4075 EL CAMINO WAY

PC Amendment

July 18, 2024

Architectural Review Board

PROJECT ELEVATIONS REAR – FACING WILKIE WAY

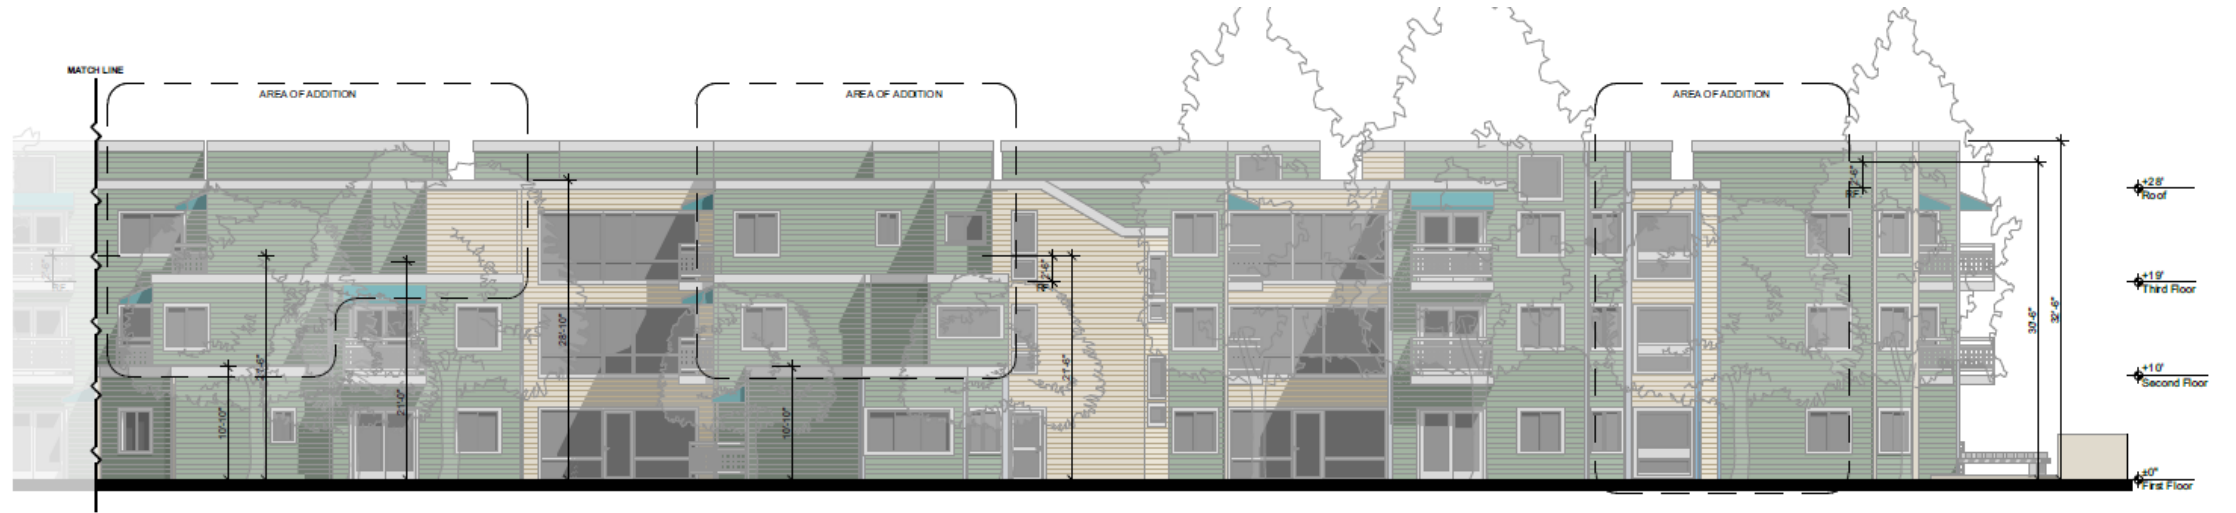
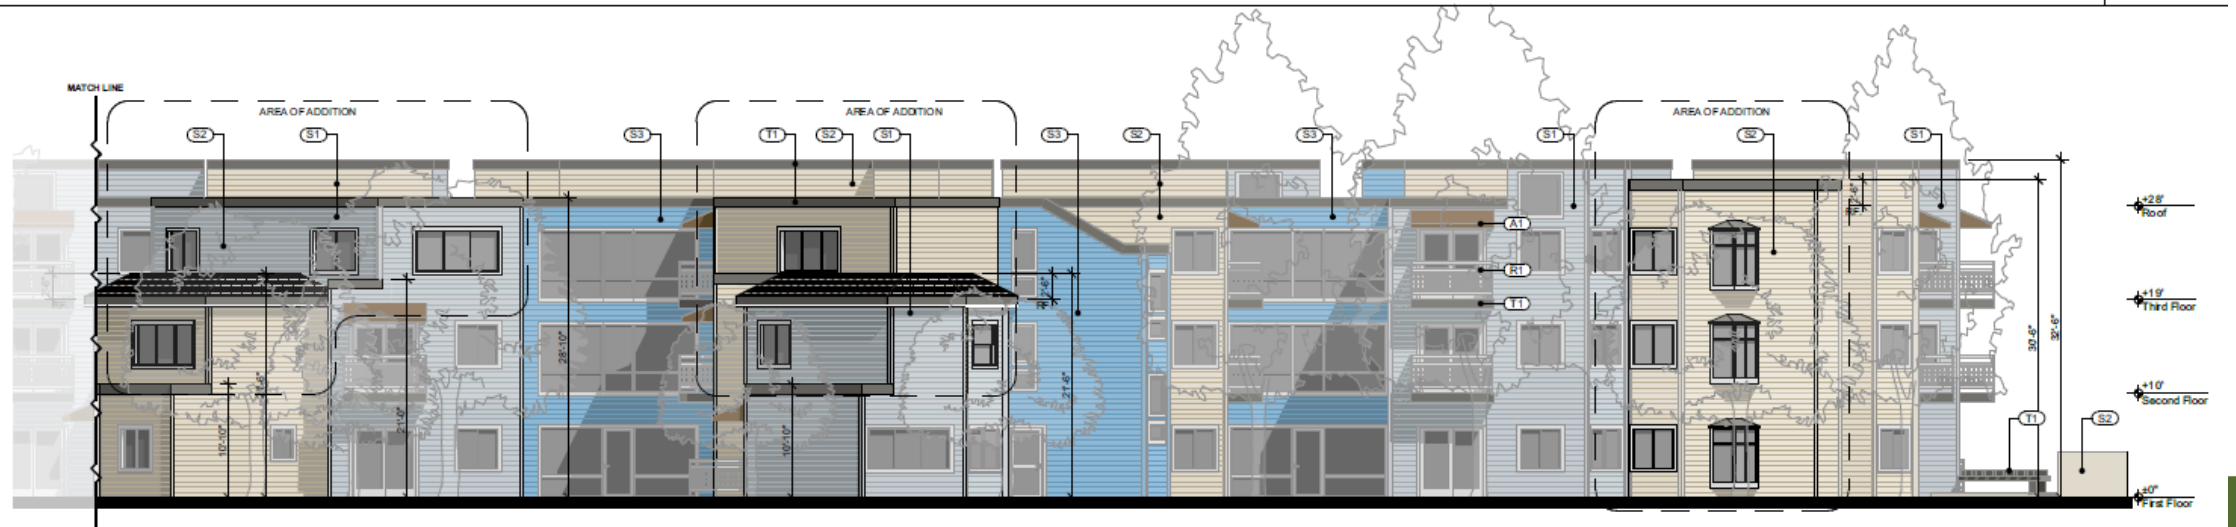
- Upper floor setback from the Wilkie Way neighborhood
- Window privacy measures, similar to IR Guideline Requirements
- Noise mitigation measures
- Landscaping for privacy

- Current upper floor setbacks vary from 12 ft to 21 ft
- PTC asked if it is possible to increase this setback to 20 ft, however it is likely that this is unfeasible or would result in loss of units

- PTC recommended consideration of privacy glazing, screening, and alternative locations for windows, similar to IR Guideline requirements
- Privacy is a priority, however most of the proposed units have only 1-2 windows, and residents spend more hours of the day in their homes than a typical residence.
- The IR Guidelines would consider windows that are 20 ft away facing a rear yard such as this to meet requirements, so generally the third floor meets this standard.

- Desire for the step-backs adjacent to the single-family houses to be maintained, disagreeing that the 45-degree daylight plane is appropriate
- Concern about increased shade in neighbors' rear yards
- Concern about visitors and staff parking on local streets, rather than on site
- Concern about noise during peak operation of HVAC equipment
